VALUE ENGINEERING CHANGE PROPOSAL
MISSOURI DEPARTMENT OF TRANSPORTATION

Contract ID 080822-404 | Job No. J4I1641D

VECP# 09-25 (to be completed by C.O.) | VECP ☒ or VECP/PDU ☐

1. Description of existing requirements and proposed change(s). Advantages/Disadvantages
   Bridge A21163 and A21164 Bent 2 is designed with pile footings for crash wall. Proposal is to change to drilled shafts to support the crash wall. This eliminates the need for temporary shoring of the UPRR tracks.

Sheet No. 10A of 33

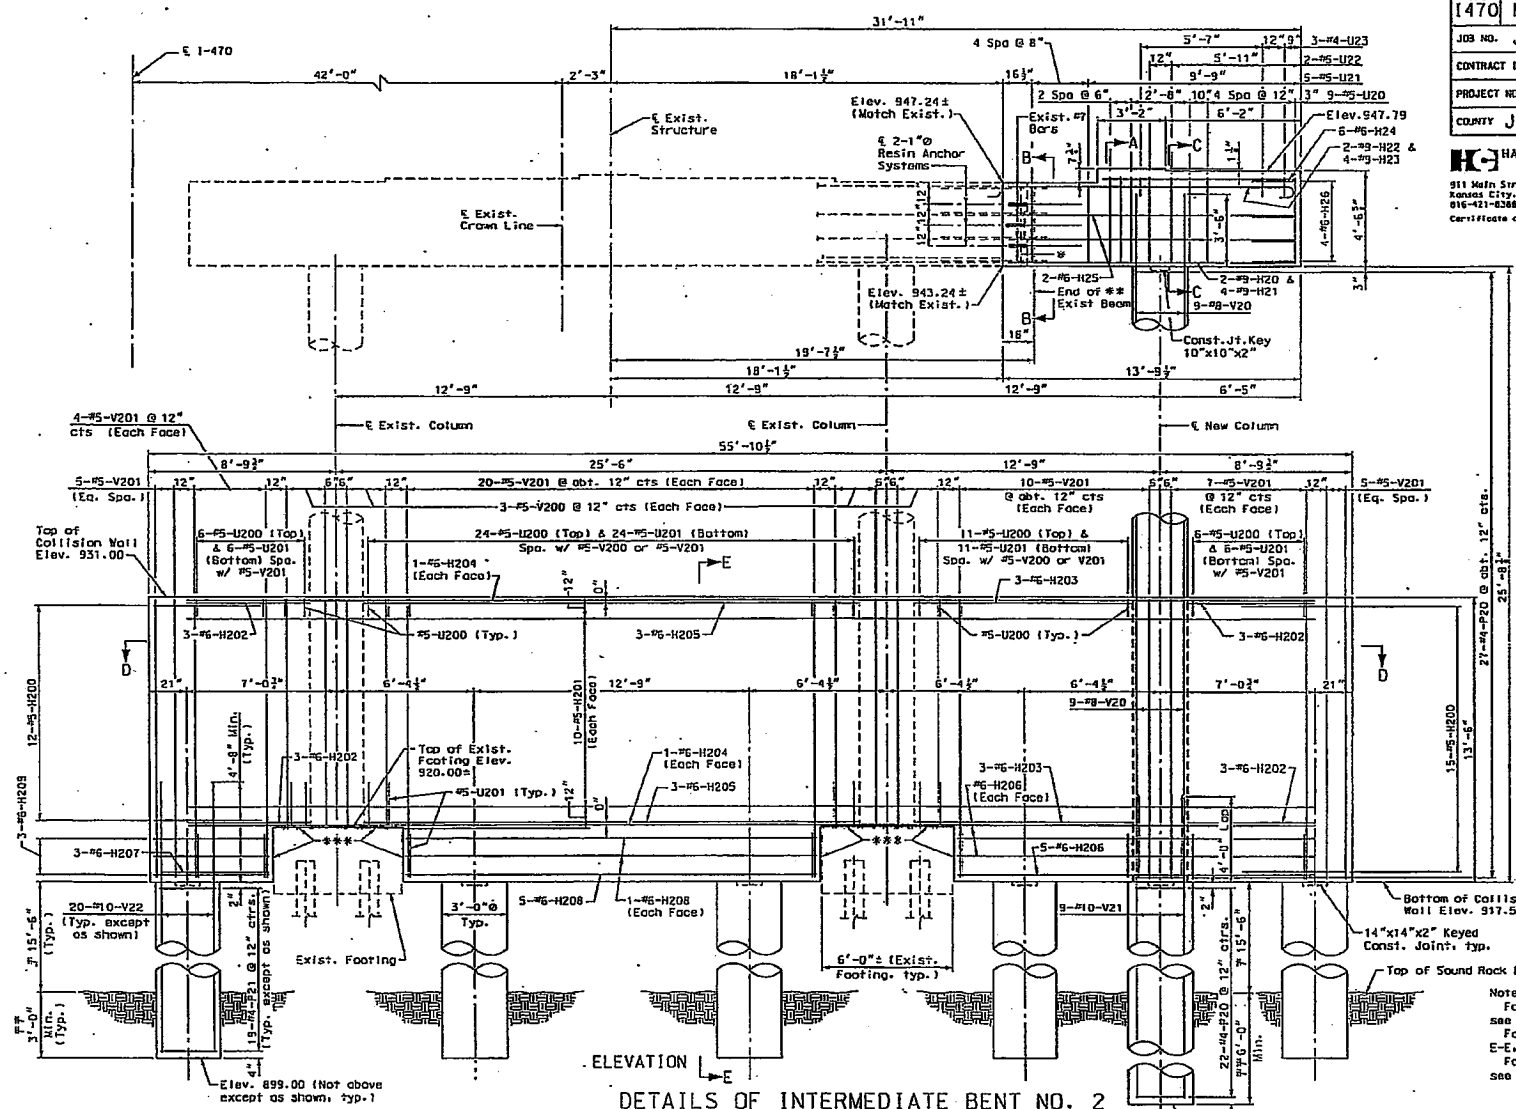
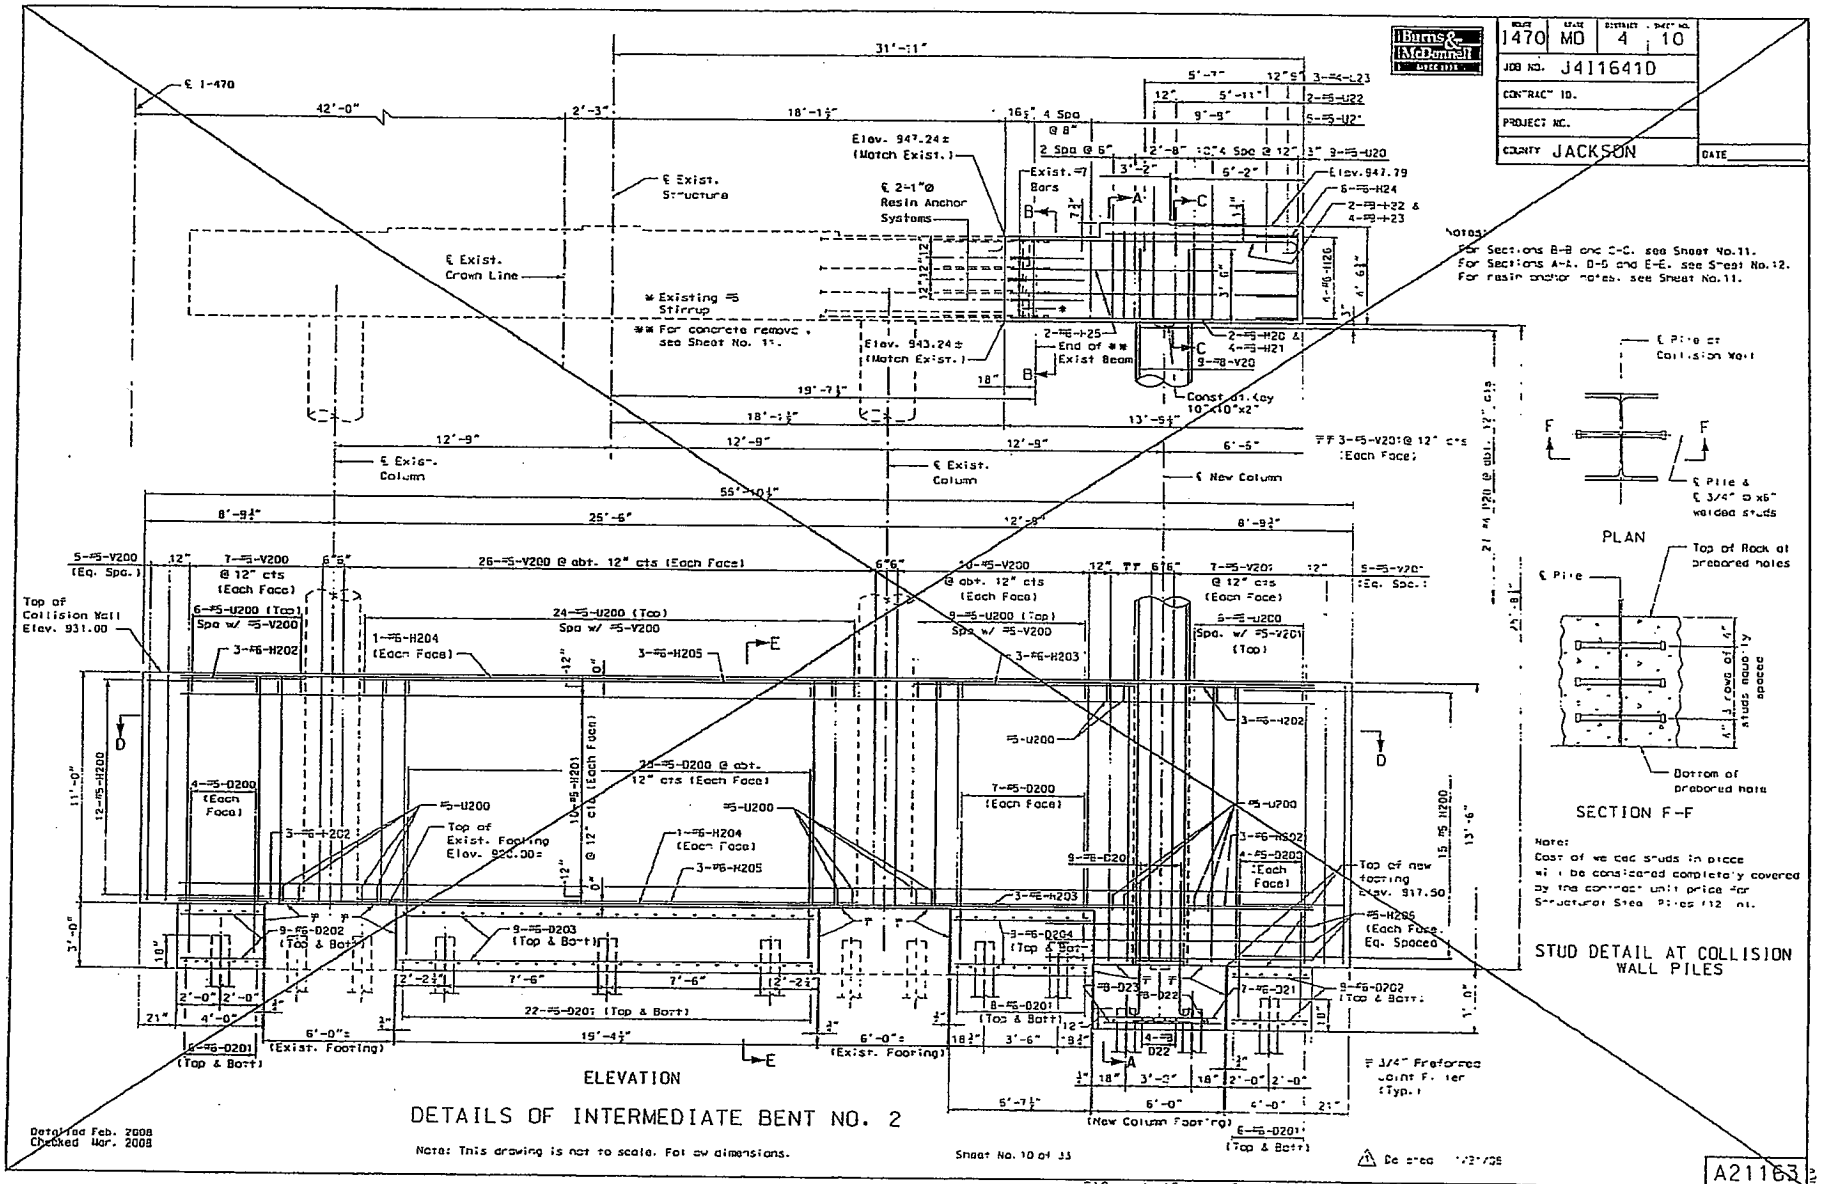
(***) See Sheet No. 10A for elevations of Drilled Shaft and Rock Sockets.

PLAN

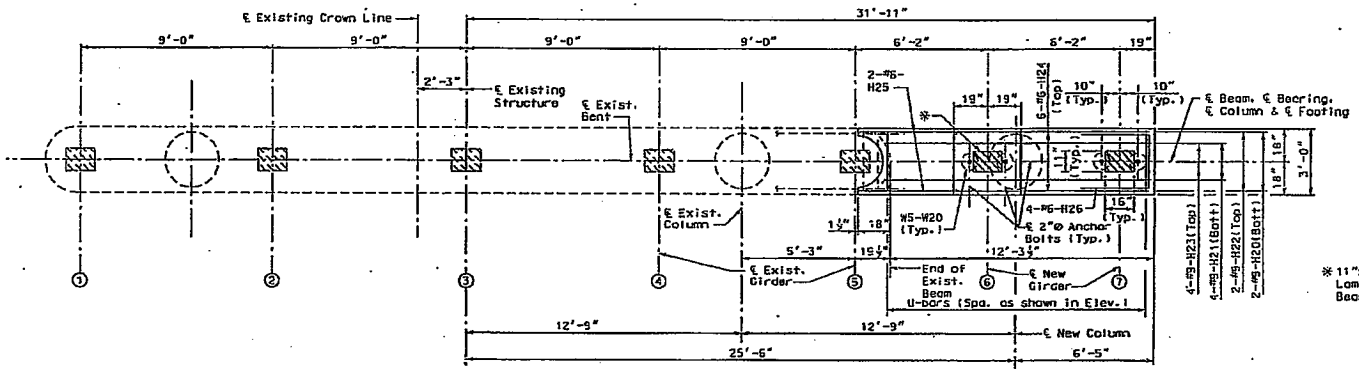
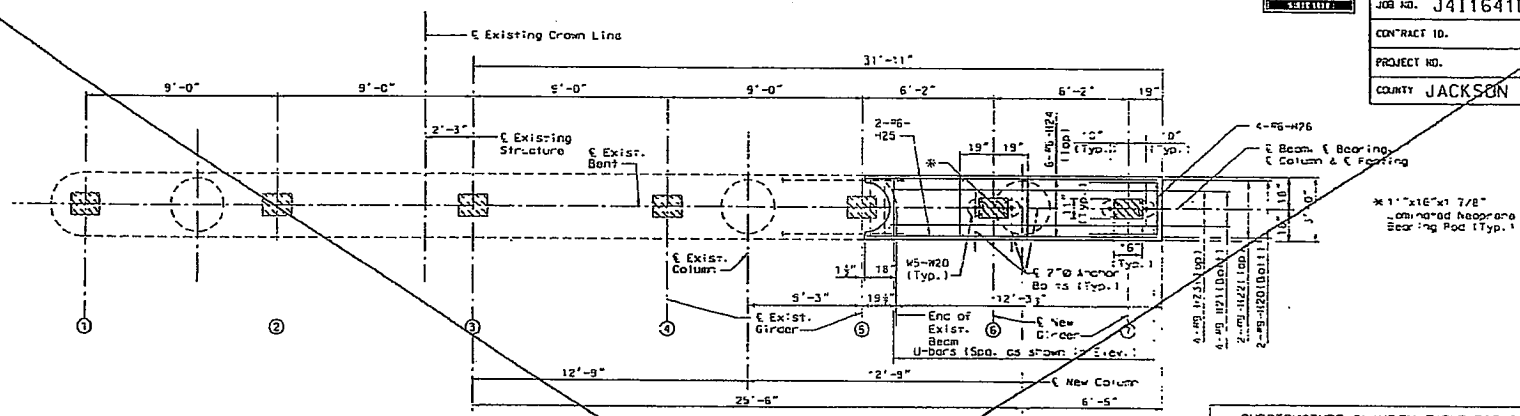
SUBSTRUCTURE QUANTITY TABLE FOR BENT NO. 2		
ITEM		QUANTITY
Class 1 Excavation	cu. yard	121
Drilled Shafts (3 ft. 0 in. Dia.)	linear foot	93
Rock Sockets (3 ft. 0 in. Dia.)	linear foot	21
Foundation Inspection Holes	linear foot	81
Concrete Coring	linear foot	22
Class B Concrete (Substructure)	cu. yard	97.2
Reinforcing Steel (Bridges)	pound	18,410

FOOTING & PILE DATA

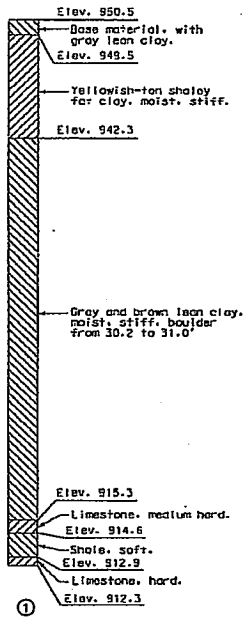
Casing Question
The UPRR approved the design change to drilled shafts at Bt 2 provided MoDOTs geotechnical group confirmed if a temporary or permanent steel casing is required to prevent the hole caving in. This question was submitted to Alan Miller, and Alan's reply was based on the information he had for Bents 1 and 3 (he did not have geotech info for Bt 2). He stated it appeared that temporary casing would suffice, but since the holes would be adjacent toa RR he recommended permanent casing.

Minimum energy requirement of hammer is based on plan length and design bearing value of piles.
All piles, except for Bent No. 2 collision wall, shall be driven to practical refusal.
Prebore for piles at Bent No. 2 to elevation 902.5.
Prebore for piles at Bent No. 5 to elevation 927.00.
Backfill all prebored piles in accordance with Sec 702.4.3.
Manufactured pile point reinforcement shall be used on all driven piles in this structure.
For rock socket allowable side resistance values, see Table. End bearing shall not be considered.
Concrete coring shall be performed on Bent 2 (column) drilled shaft and rock socket.

Sheet No. 10A of 34

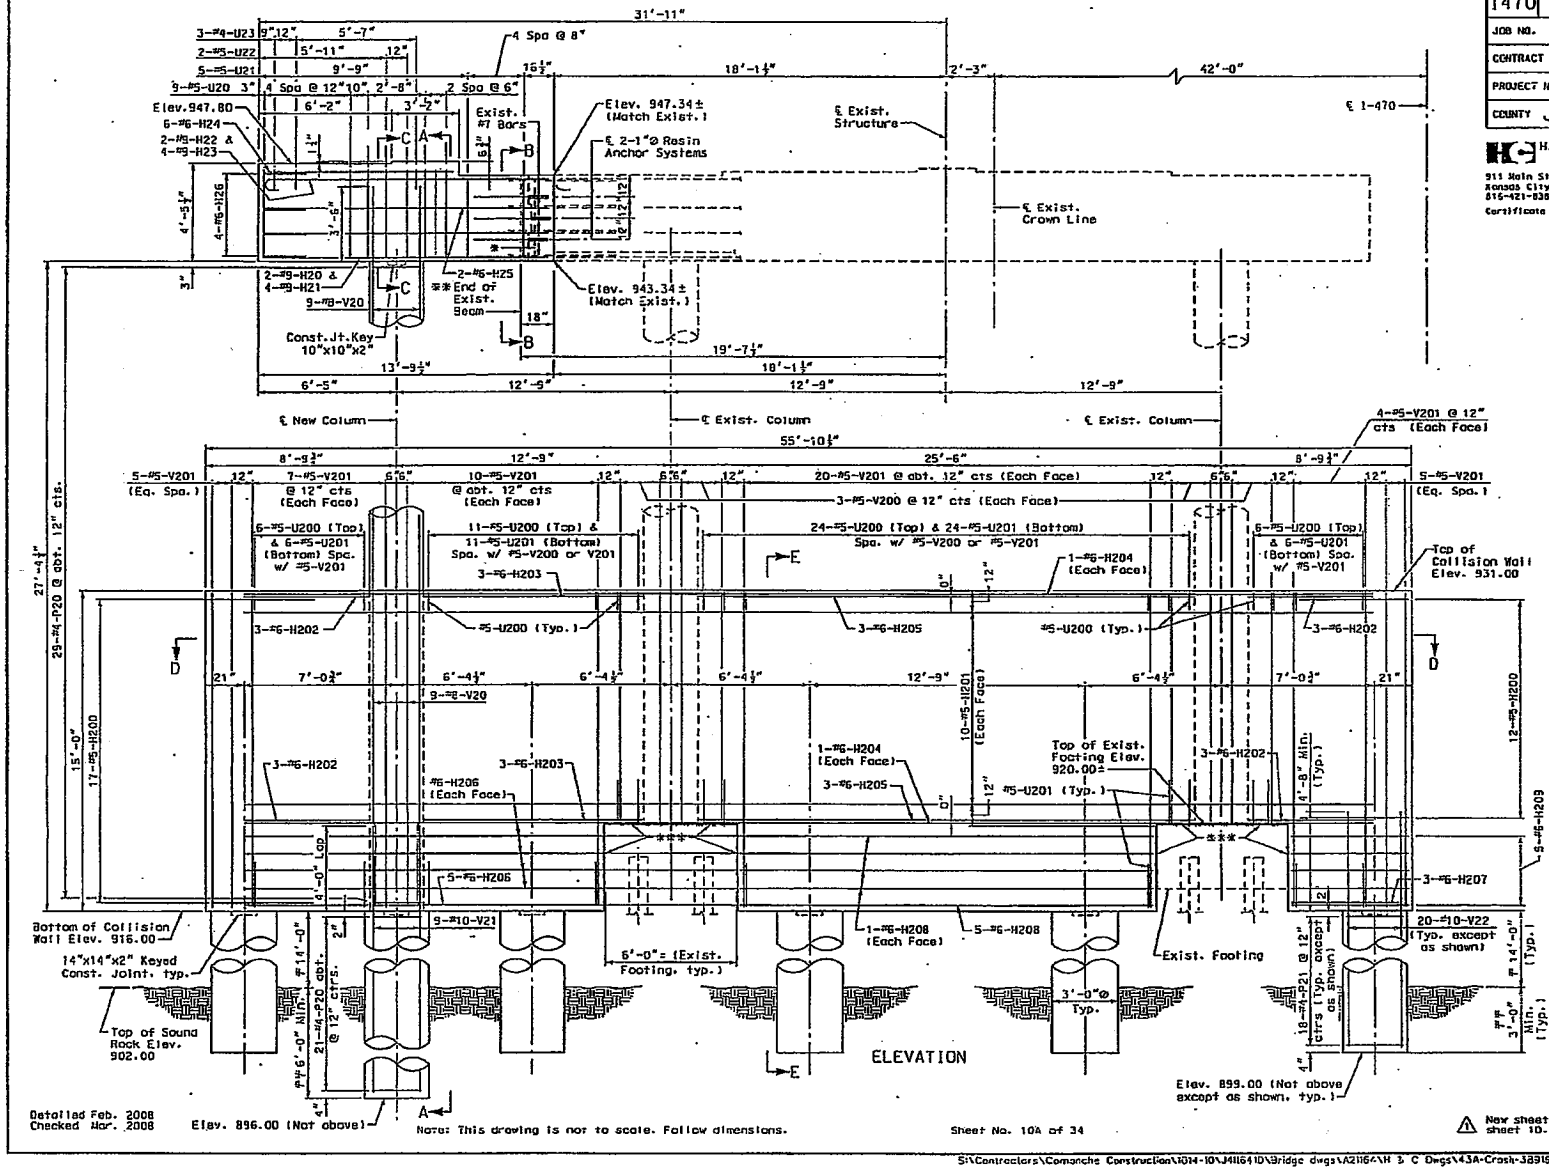
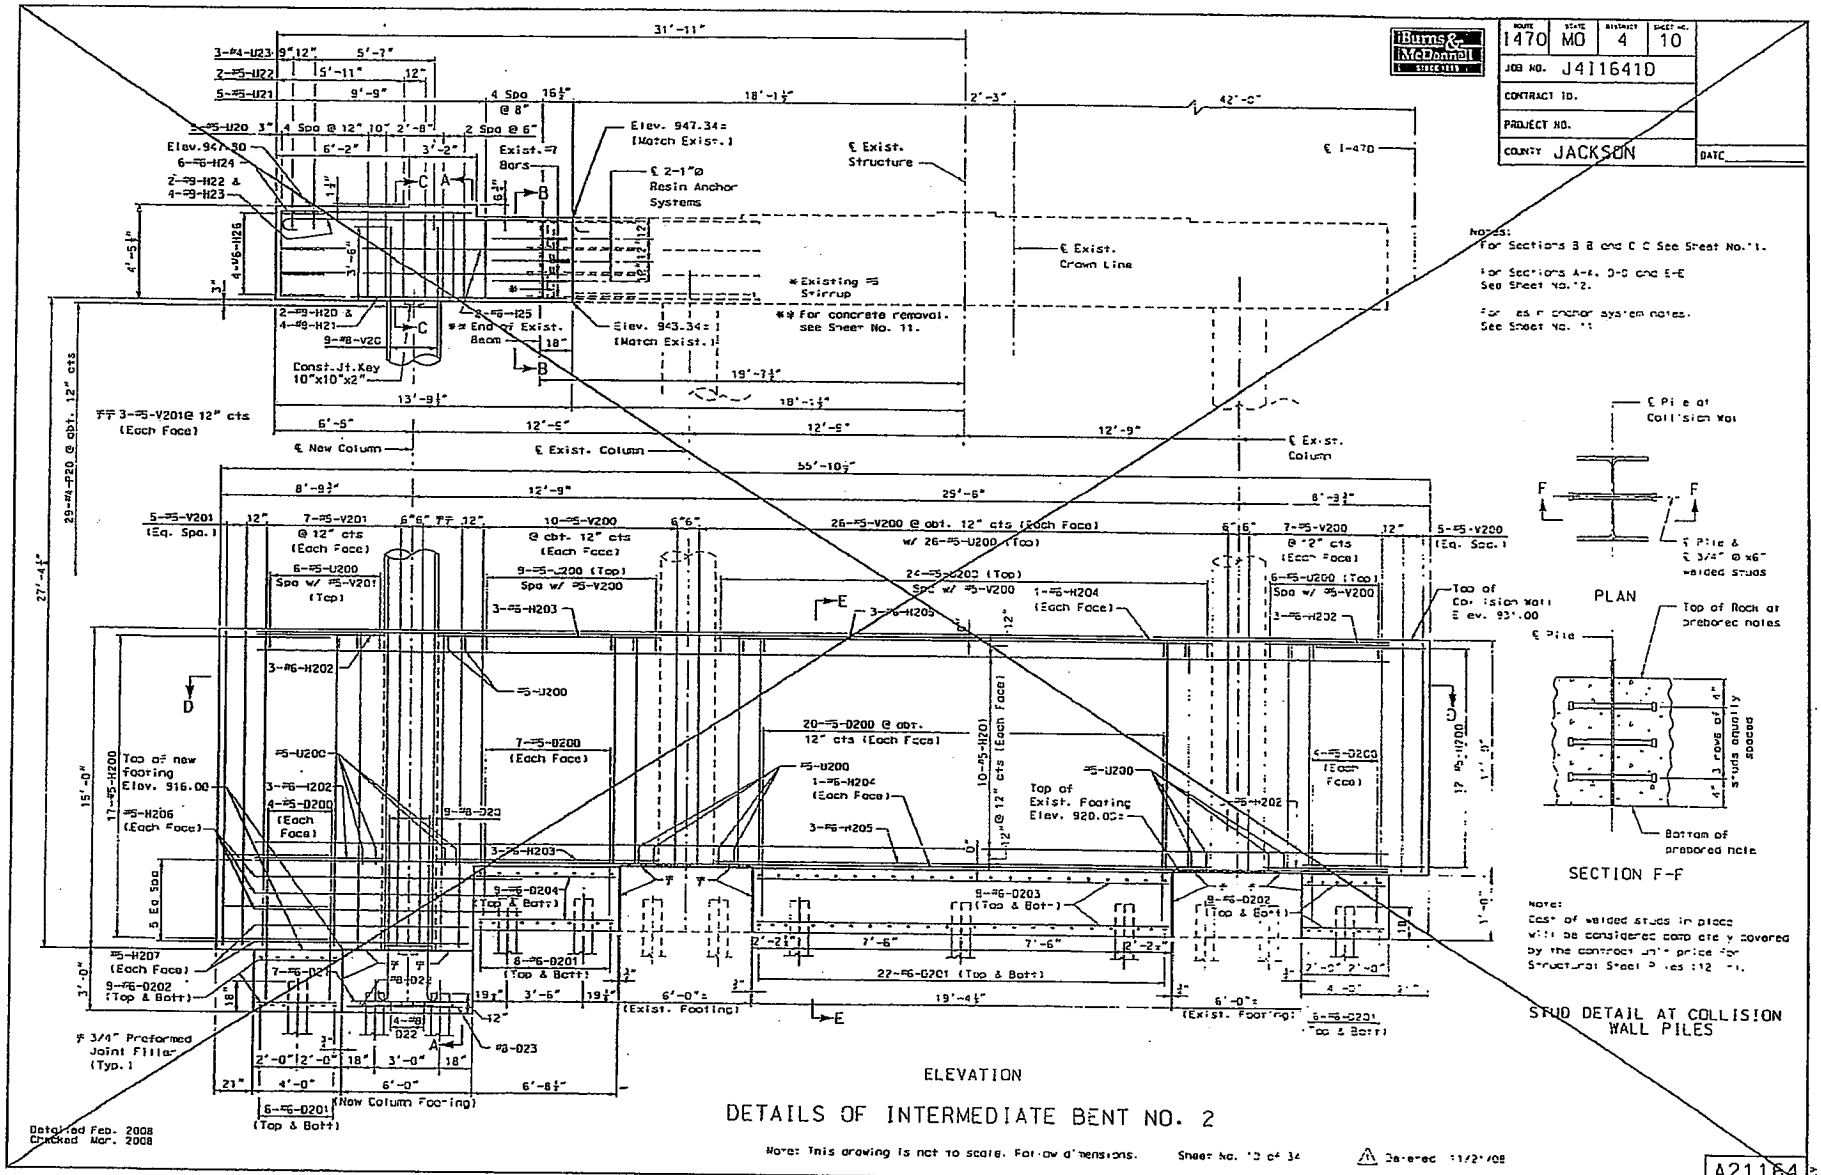
** For concrete removal, see Sheet No. 11A.
